Urgent Field Safety Notice
Molecular Diagnostics at Abbott
Product: Alinity m System
List Numbers: 08N53-002
Not Serial Specific
Unique Device Identifiers (UDIs): 00884999048034

March 19, 2024

FA-AM-MAR2024-298B

Appendix A

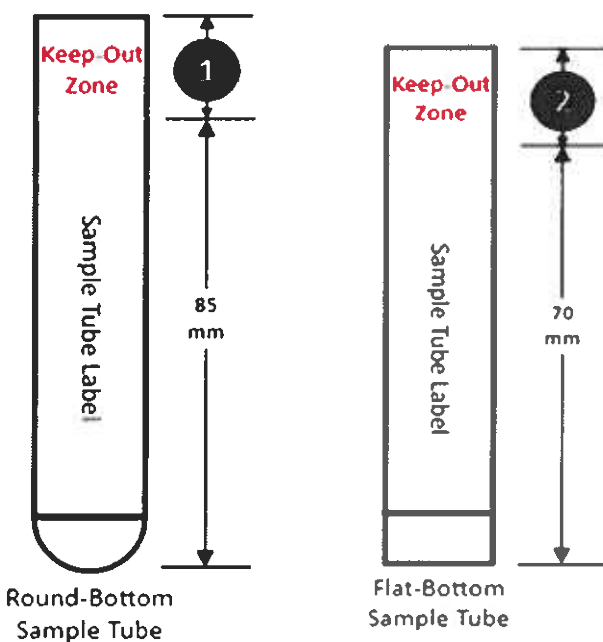
Aliquot the sample from the sample tube that is experiencing the error to a different sample tube, as permitted by the assay package insert, and ensure the following sample tube label requirements are met:

1. This area defined as ① is the keep-out zone for the round-bottom sample tube. The keep-out zone is the area where the sample tube label cannot contain colors other than white and black, above a maximum of 85 mm from the bottom of the tube.
2. The area defined as ② is the keep-out zone for the flat-bottom sample tube. The keep-out zone is the area where the sample tube label cannot contain colors other than white and black, above a maximum of 70 mm from the bottom of the tube.

1. Aliquot the sample into another tube permitted by the assay package insert and ensure the sample tube label requirements in Appendix A are met.

2. Cover colored portion of tube label that is present in the Keep-Out Zone, depicted in Appendix A, with white opaque material (e.g. white sticker) where the barcode is located. Avoid covering any needed sample information when applying an additional sticker to the sample tube.
